RAILWAYS AND PUBLIC WORKS:

REPORT OF THE ROYAL COMMISSION.

ROYAL COMMISSION
ON
RAILWAYS AND PUBLIC WORKS.

REPORT
OF
THE COMMISSIONERS,

AVOCA DEVIATION.

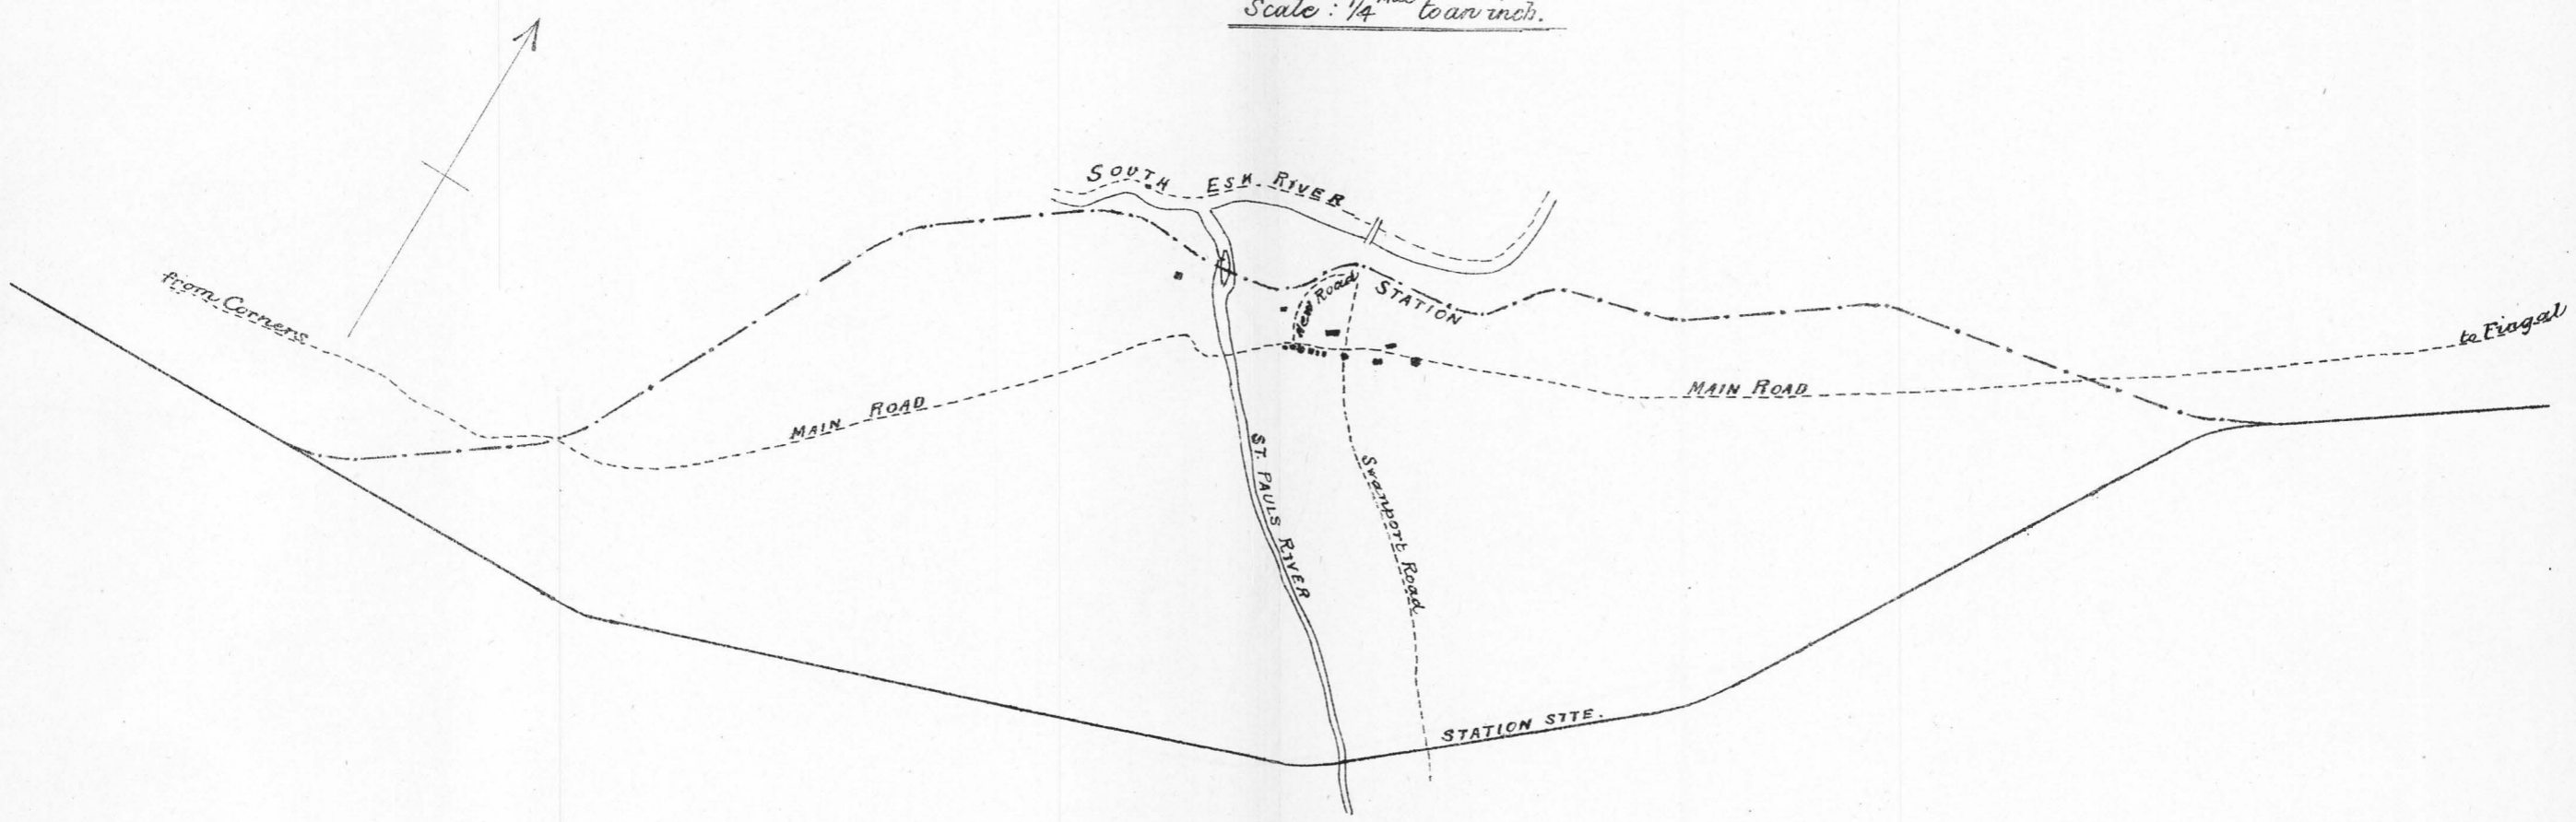
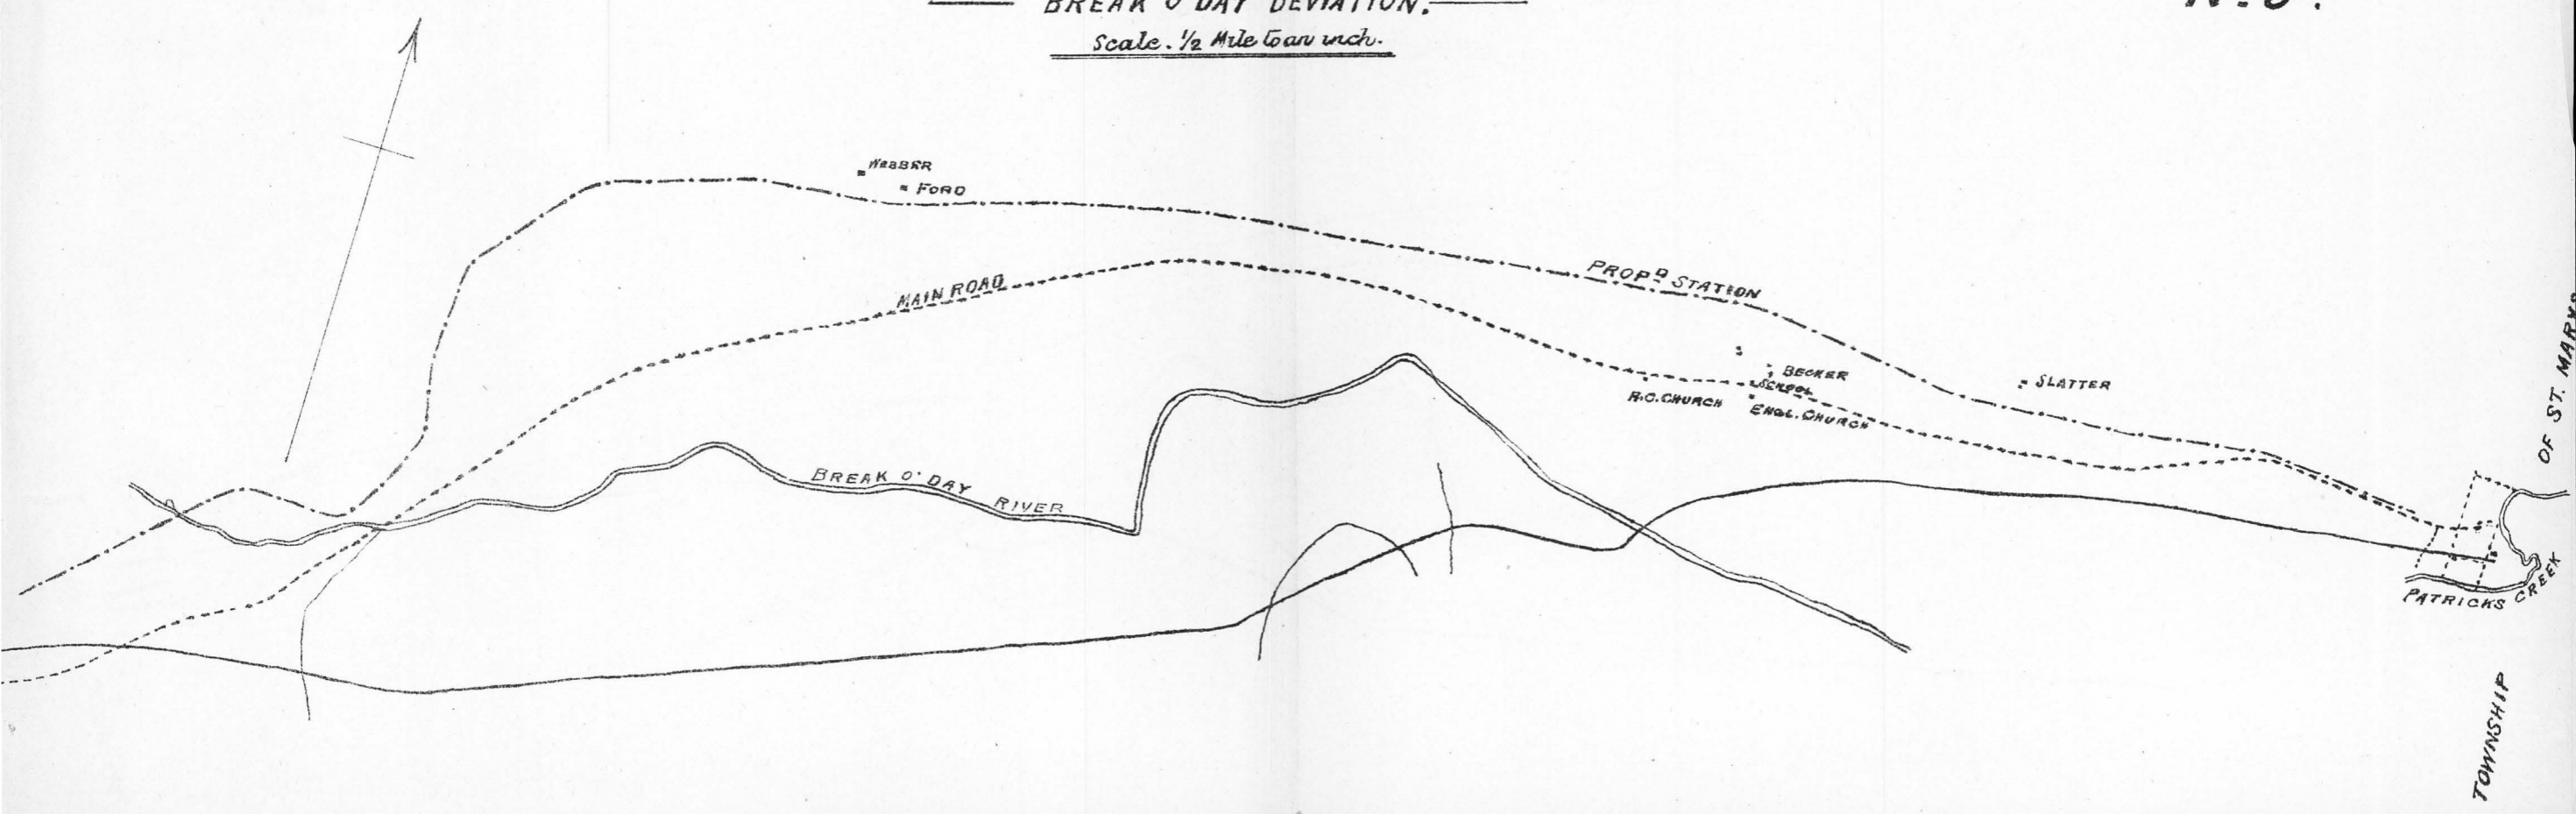
The reasons assigned for the adoption of the present line in preference to that approved by Parliament are neither very intelligible nor satisfactory. The Engineer-in-Chief admits that the weight of the evidence, both from an engineering and traffic point of view, was strongly in favour of the original line, that he himself had some years ago selected the Rockford site as the best for station purposes, and that the same had been confirmed by every engineer who had been over it (questions 3684, 3675, and 3677); but states that in order to satisfy the wishes of the residents of Avoca, who had petitioned that the line should be brought through the town, he instructed Mr. Climie to examine and report on the proposed deviation (question 3665). (See Appendix U.) This report being favourable, he recommended the Minister to accede to the prayer of the petition; but it is to be regretted that before doing so the Engineer-in-Chief did not take steps to satisfy himself of the correctness of Mr. Climie's conclusions, nor obtain any information as to the relative value of the land upon the two lines (question 3746). The deviation has been shown to have cost nearly £3000 more than the estimate of the original line (questions 3203-3670), of which £1475 is due to the extra cost of the bridge over the St. Paul's River (question 3289), whilst the station has been located in a most inconvenient position as regards the present working of the line, and one which must entail considerable future expense when the development of the traffic necessitates enlarged accommodation.

The second of these deviations, near Killymoon, was made with the object of affording better accommodation to the anticipated traffic from the Mount Nicholas coalfield (question 3936); but seeing it increased the length of the line by nearly three-quarters of a mile (see Appendix V.), and that the works have proved more costly, it is, we submit, open to question whether, in view of the coal traffic not being an established one, the alteration was warranted, and that it would not have been more judicious to provide for such traffic as it developed, by branch lines.

It appears that these deviations were not formally sanctioned, although the Engineer-in-Chief explains that he obtained the verbal approval of the Minister to them. We submit that all important deviations from the line as passed by Parliament should invariably be duly authorised by the Government; and in this view we are supported by the opinion of the Hon. the Minister of Lands and Works (see answers to questions 6675-6).
